ASSESSMENT REPORT

Woolooware Bay Town Centre Concept Plan approval (MP10_0229 MOD 6) & Project Approval (MP10_0230 MOD 3)

Figure 3 – Level 1 (Approved) (Source: Proponent's modification application, 2016).

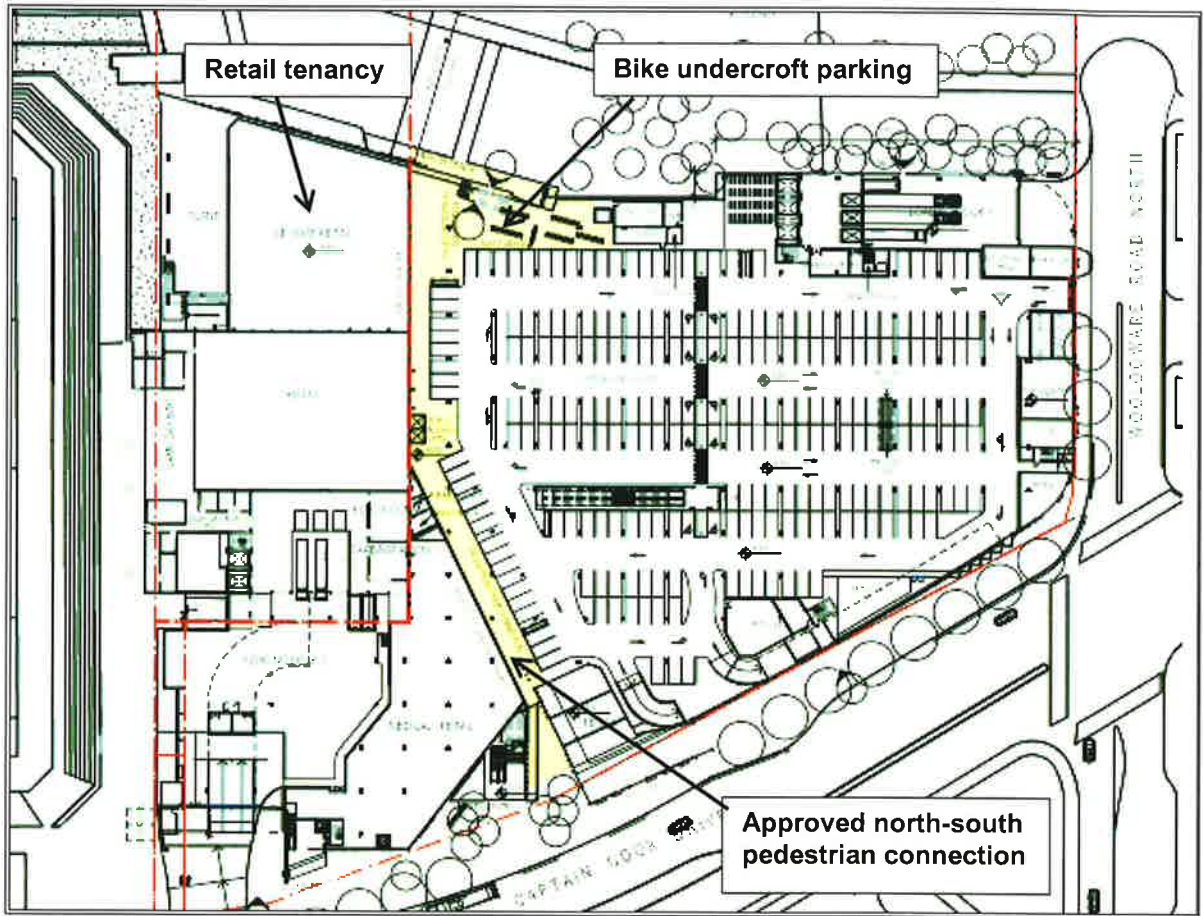
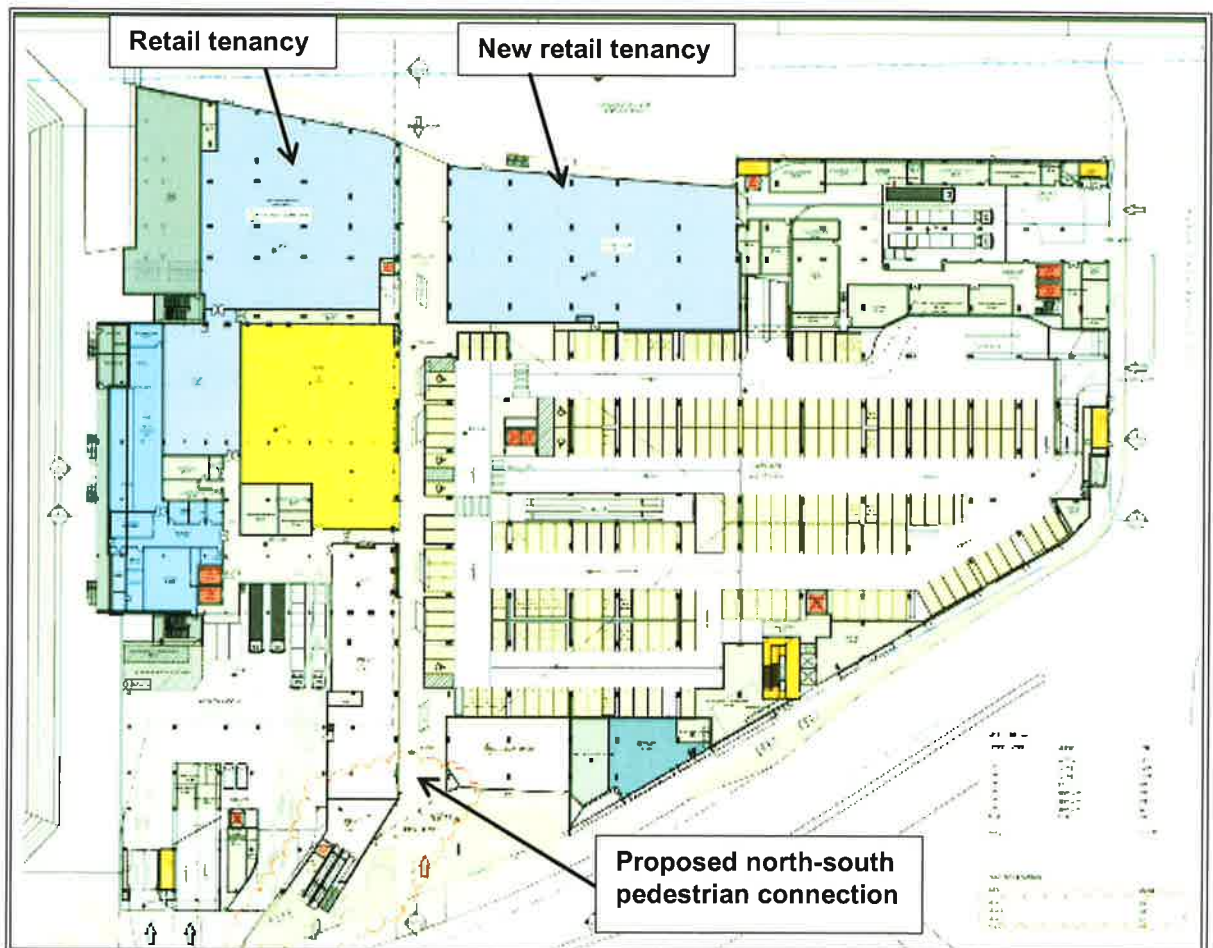
The Department notes the proposed modification includes additional retail tenancies at ground level fronting the foreshore compared to the approved development (refer to **Figures 3 and 4**). Subject to these retail tenancies providing a suitably glazed shopfront along the foreshore frontage, the Department is satisfied the proposed modification would result in improved building activation and surveillance along the Woollooware Bay foreshore frontage. Consistent with the approach taken for the other frontages in Condition C20 discussed in **Appendix C**, the Department has recommended a condition requiring 75 per cent of the shop fronts facing Woollooware Bay to be suitably glazed to maximise activation and amenity of this space.

Figure 11 – Southern elevation (Captain Cook Drive) – approved envelope shaded blue (Source: Proponent's modification application, 2016).

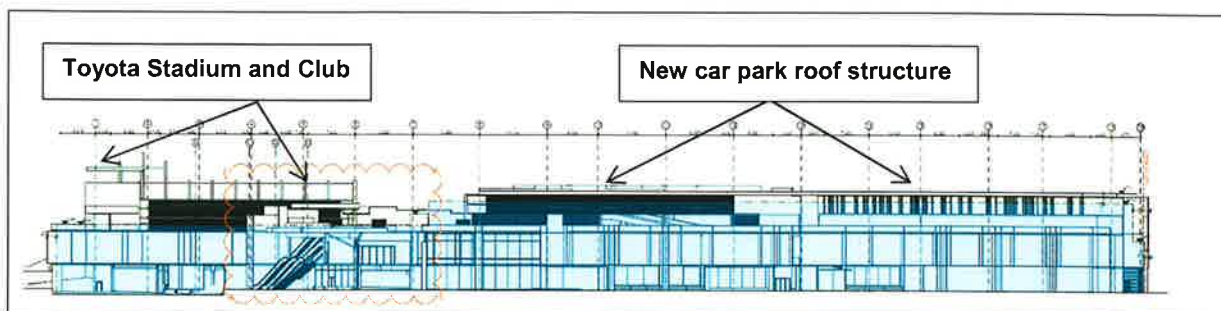
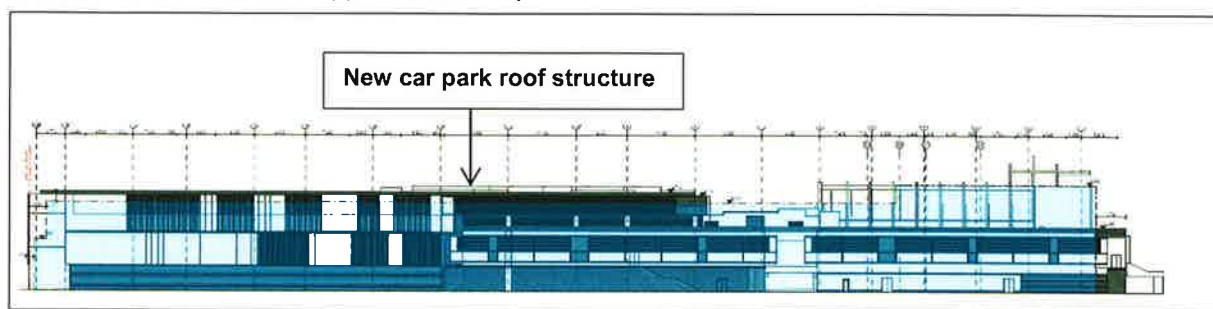
The proposal also seeks approval to extend the Level 4 car parking deck (within the approved building footprint) and provide a roof structure over the car parking area. This would increase the height of the approved building by 2.68 metres (from RL 18 AHD to RL 20.68 AHD).

The proposed car park roof extending above the approved building envelope is illustrated in **Figures 11 and 12**.

Despite the additional height the Department notes the Concept Plan approval already provides for a roof structure above part of the car park at RL 22.3 AHD. The proposed new roof would be located over a wider area, but would be 1.6 metres lower than the maximum building height allowed under the Concept Plan approval. The Department also notes the modified building height would continue to be below the 25 metre height limit applying to the site under clause 4.3 of the Sutherland Shire Local Environmental Plan 2015.

The Department considers the proposed roof structure would not significantly increase the height of the approved building or result in any adverse visual or amenity impacts to the surrounding area. The Department also considers the additional architectural and landscape detailing in the modified proposal (including additional glazing and a wider variety of facade materials) would improve the visual interface with the surrounding area compared to the original approval.

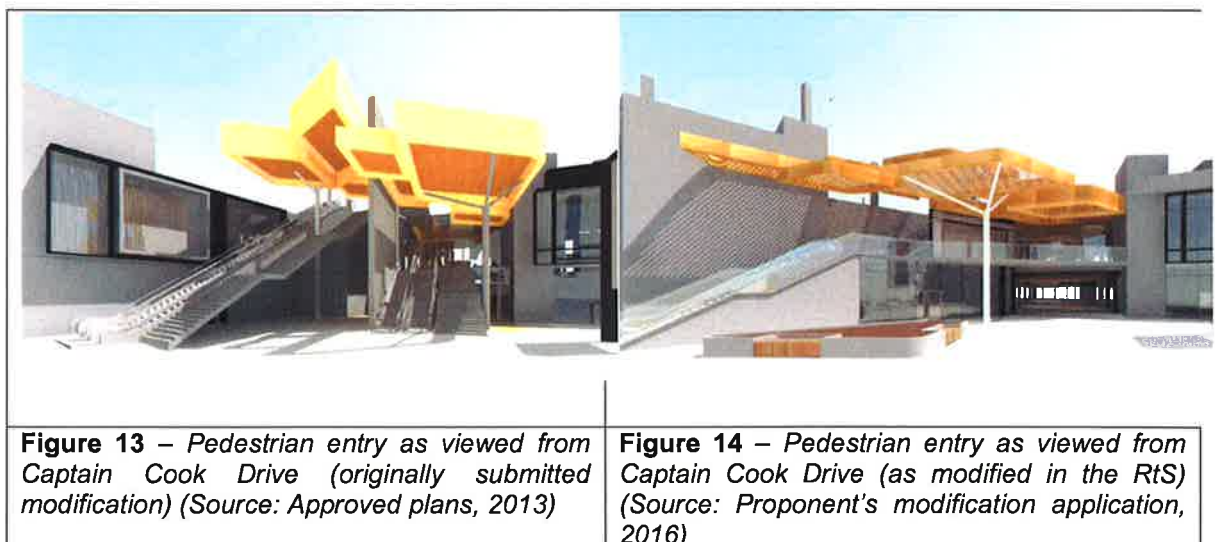
The key change to pedestrian access involves the straightening of the north-south pedestrian connection between Captain Cook Drive and the foreshore.

Council raised concern that the ground floor pedestrian entry and the north-south pedestrian connection to the foreshore was not clearly legible when viewed from Captain Cook Drive.

The Proponent subsequently amended the pedestrian forecourt entry by relocating the Level 2 retail stairs and Level 3 Club escalators to the western edge of the forecourt. The Department considers the amendments would make a significant improvement to the visibility and legibility of the pedestrian connection to the foreshore (refer to **Figures 13** and **14**).
